Project: Farmhouse Community Center  
COR #: 001 – Cost Savings and Function Options

Farmhouse Community Center Cost Savings and Function Options  
June 20, 2023

The following is a list of questions trying to identify potential cost savings and functionality improvements on the Redmon house renovation. The responses for each item to be included with the initial cost savings Change Order is noted.

3 FLOOR PLAN  
1/4" = 1'-0"

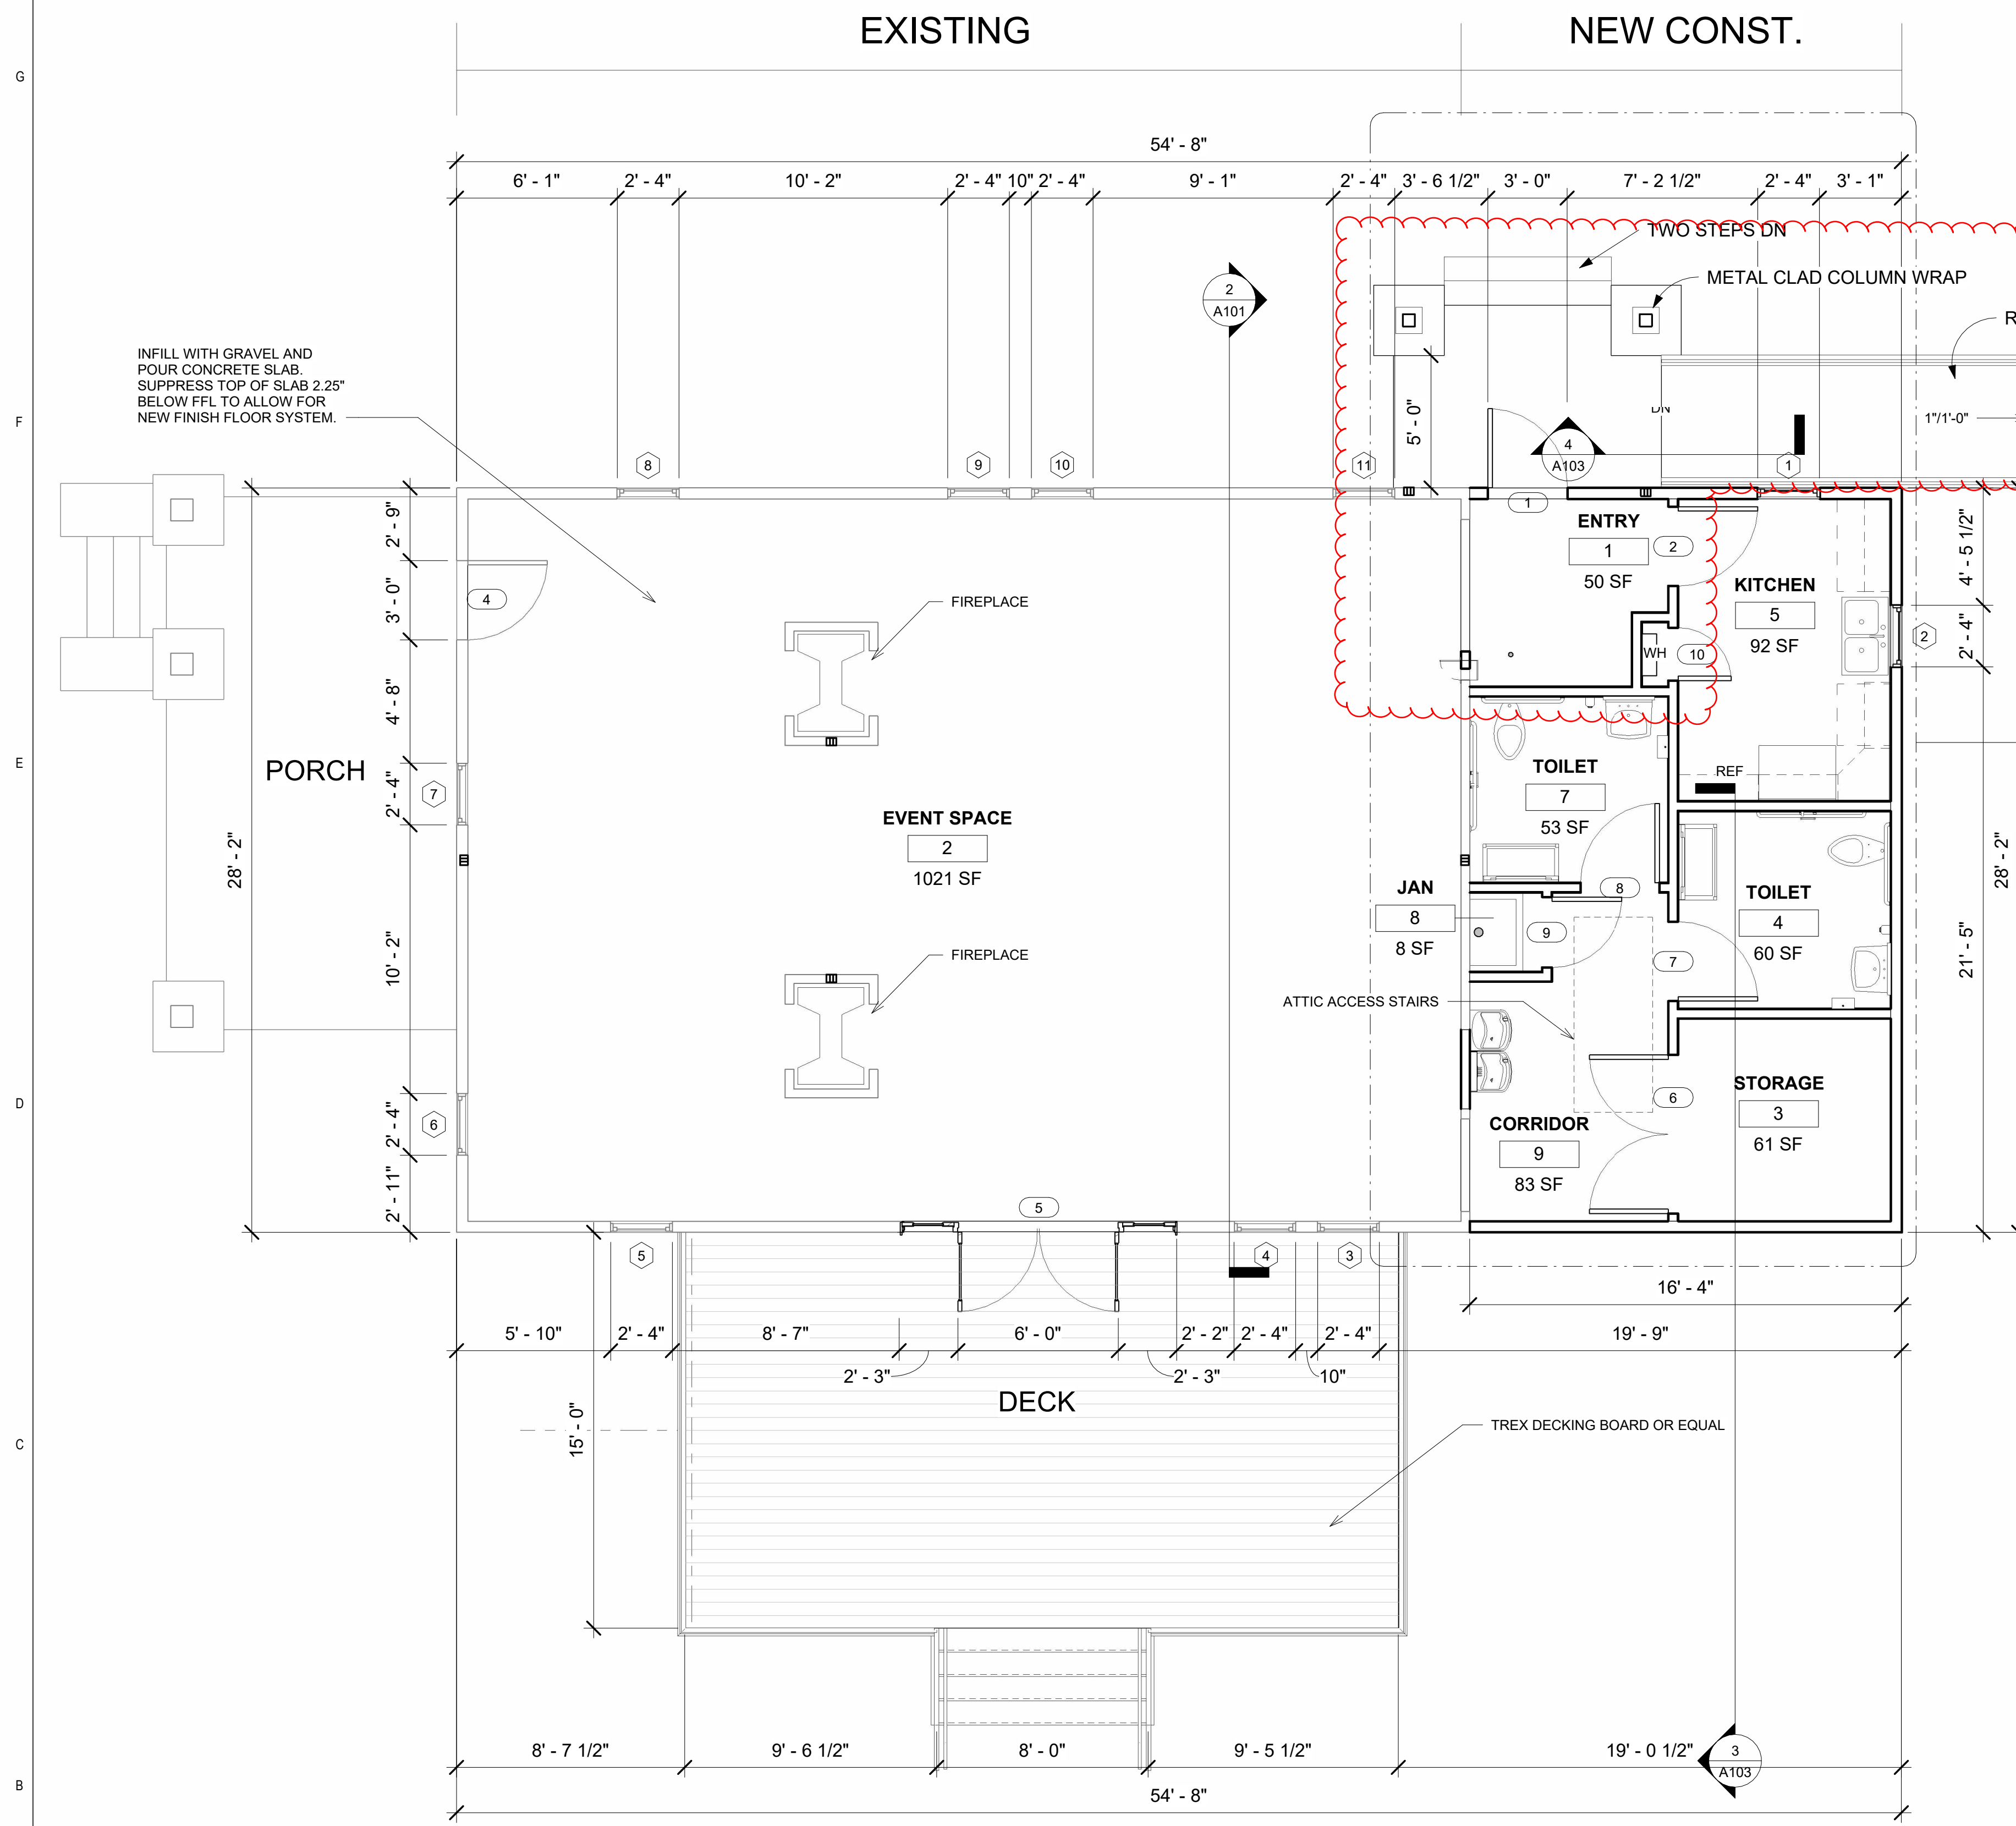
4. There has already been discussion on creating a foyer at the ramp entrance on the side of the house by eliminating the closet. Assuming we eliminate the Rinnai, it appears we can eliminate the closet in which it is shown, and further expand the foyer area off the handicapped entrance. Does that closet have another use?

Response: See attached sketch for the revised Foyer.

The owner is providing the hydropneumatic tank. The closet will need to be revised based on the size of the tank selected if we stay with the tankless gas system.

**L-101**

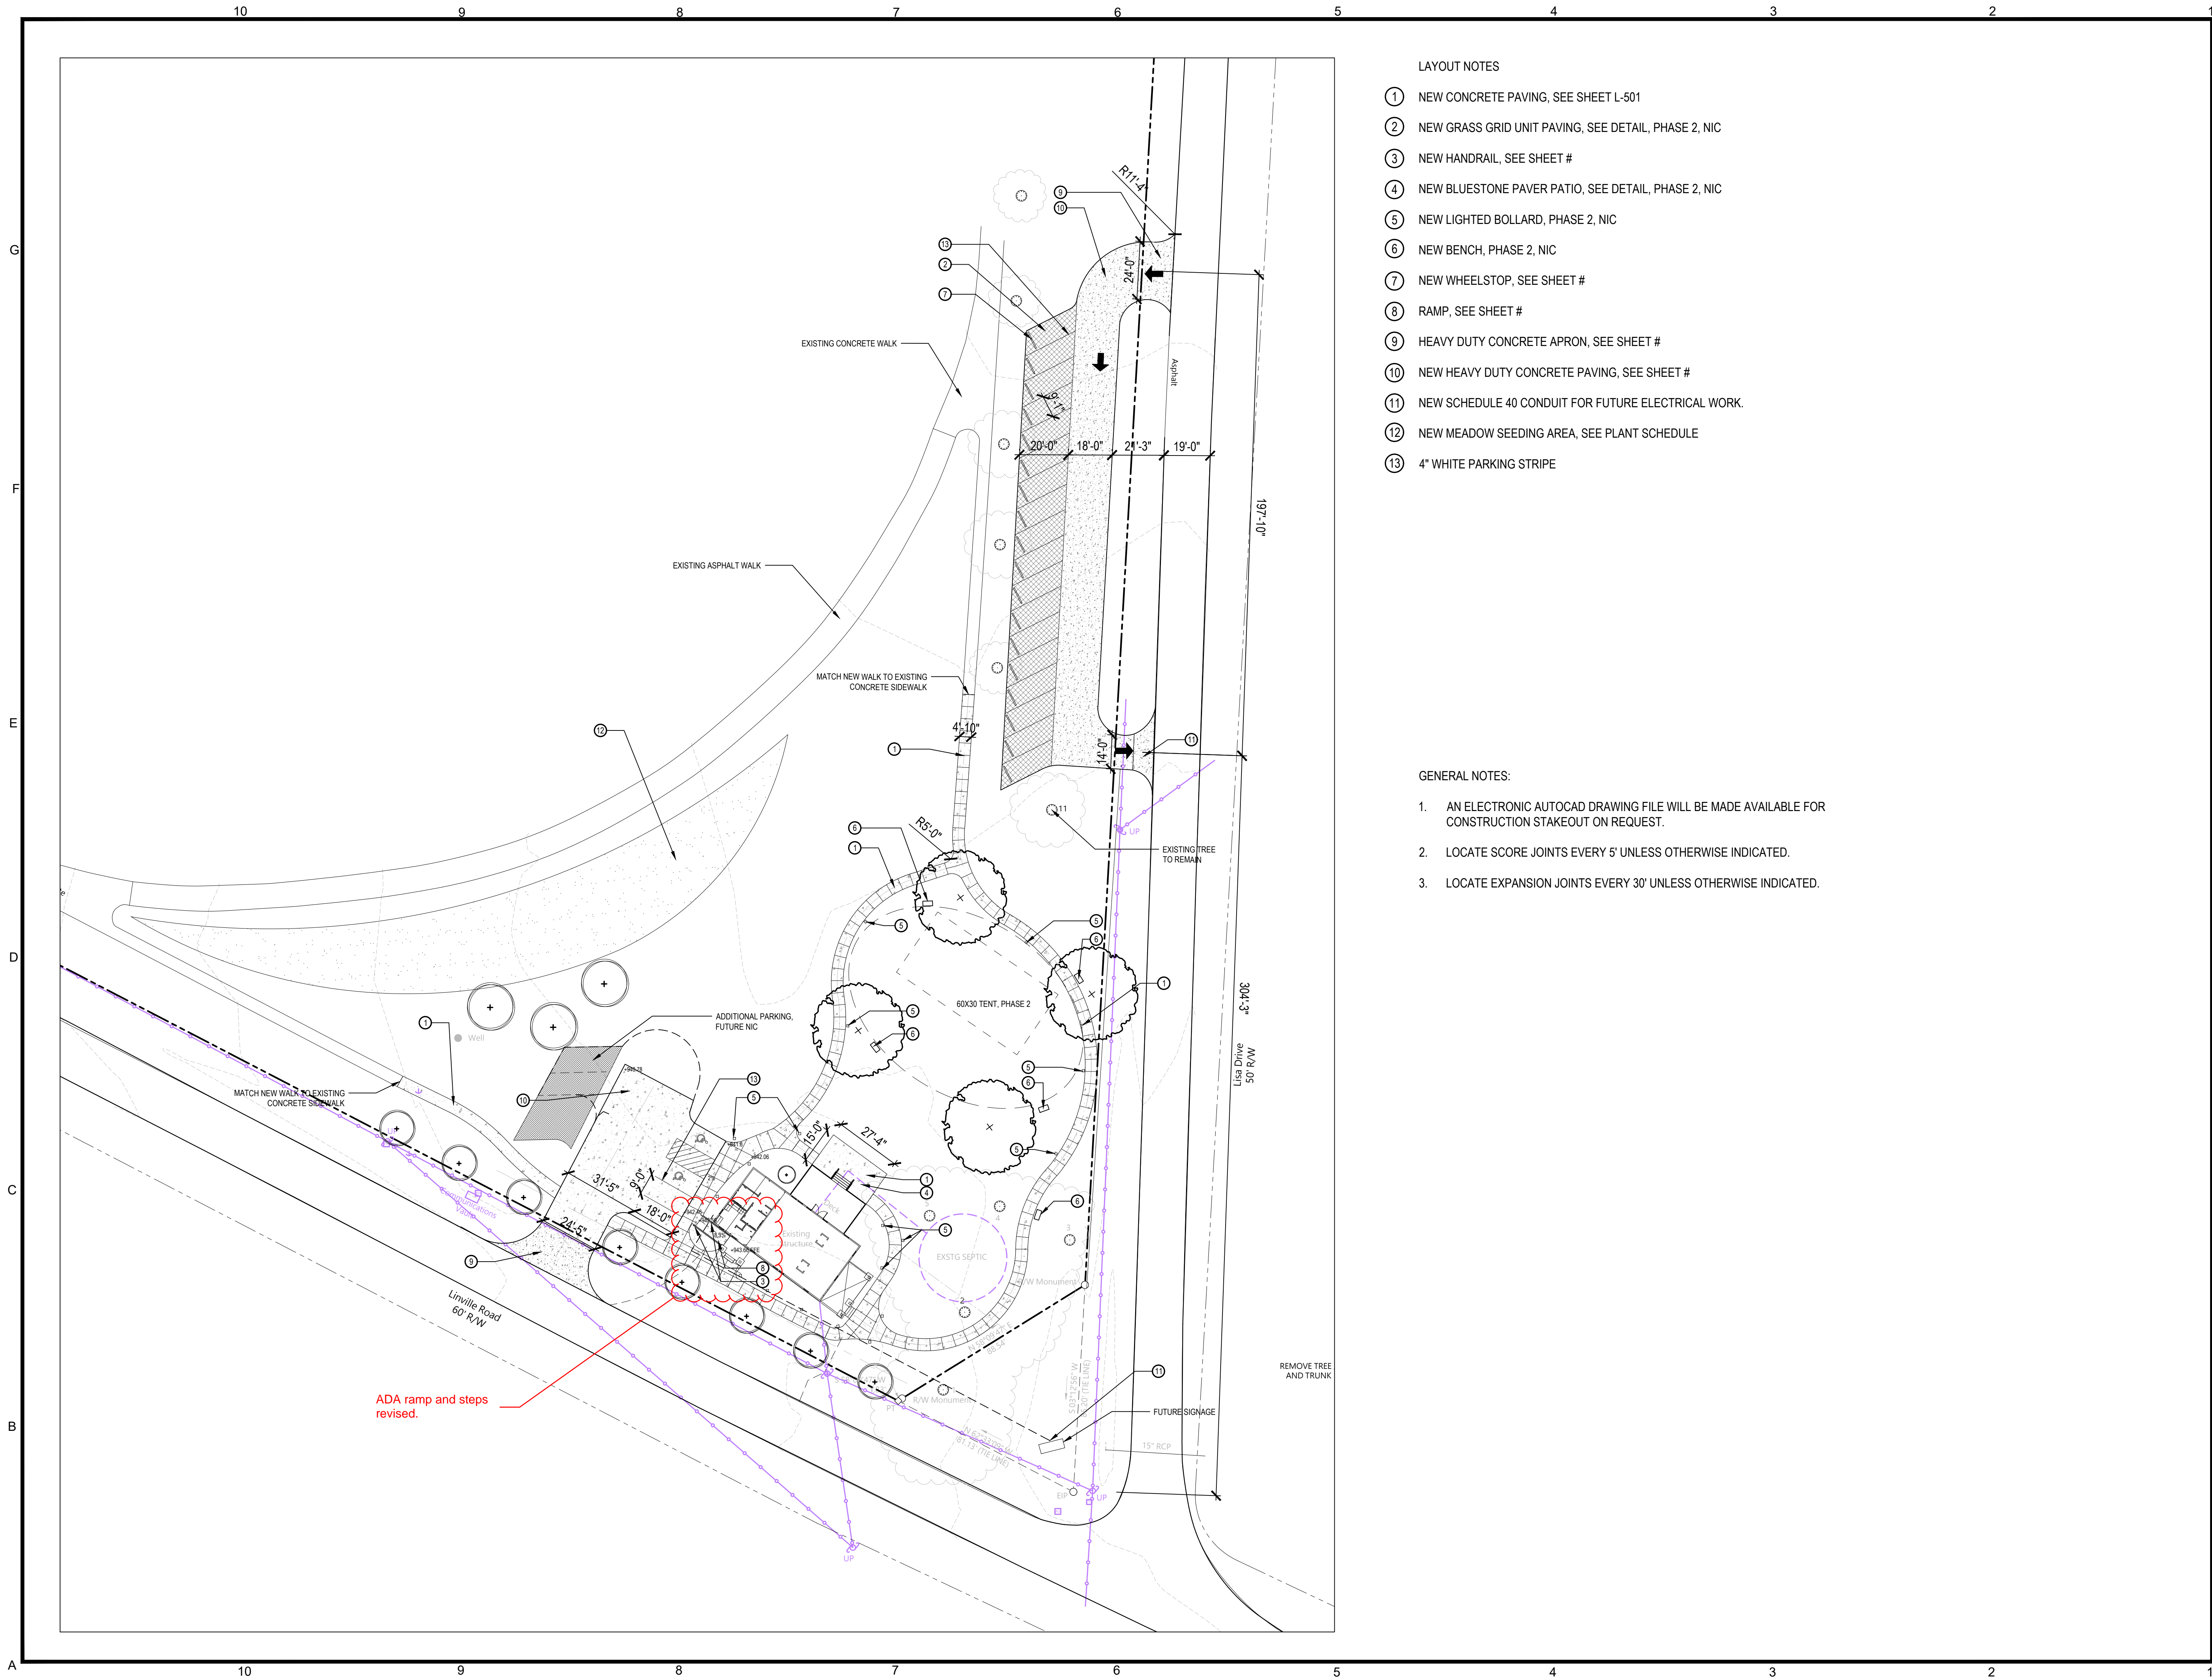
15. Entrance and ADA ramp has changed see the attached. Building Contractor to provide porch and entry slab. Site Contractor to provide ADA ramp and railing.  
Response: What is the savings from the building General Contractor, BAR? See attached revision.
